In instruments with serial no. below 1204806 the following fault may occur:

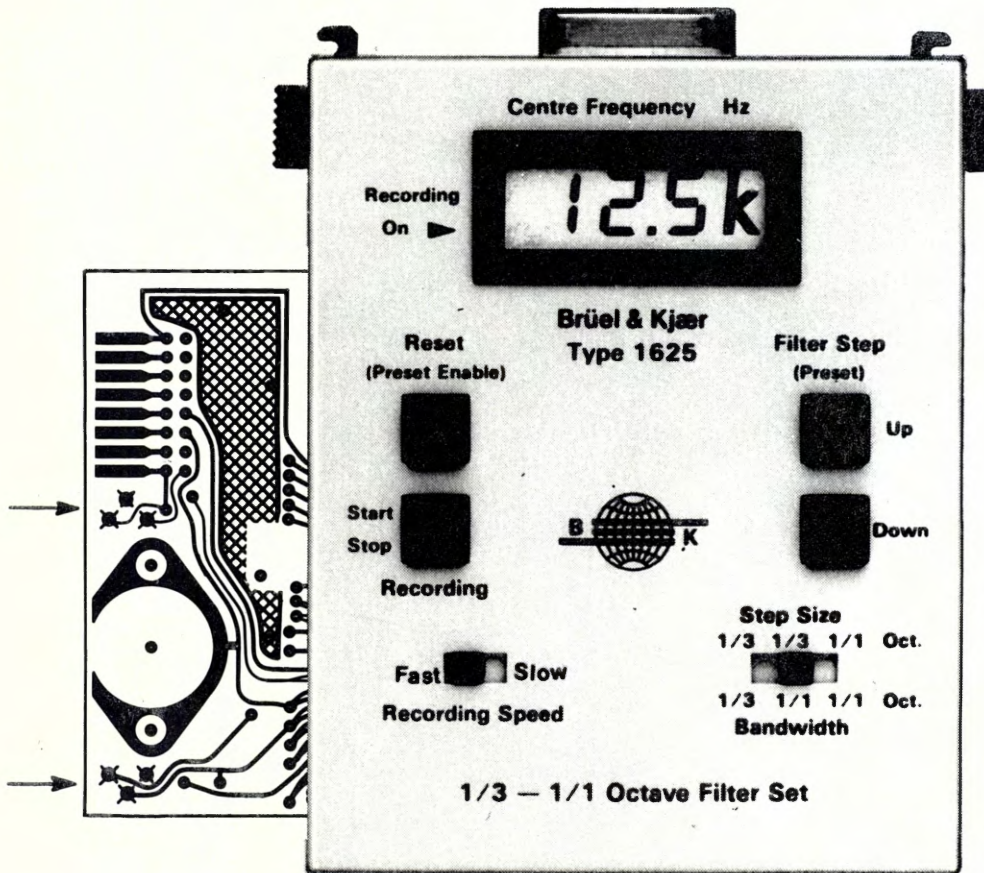
The wires through the P.C. Board (refer to the picture above) may be too long. This cause in some cases shortcircuit to chassis which again disturb the control between The Type 2306 and 1625.

Please check the instruments you may have at your stock.
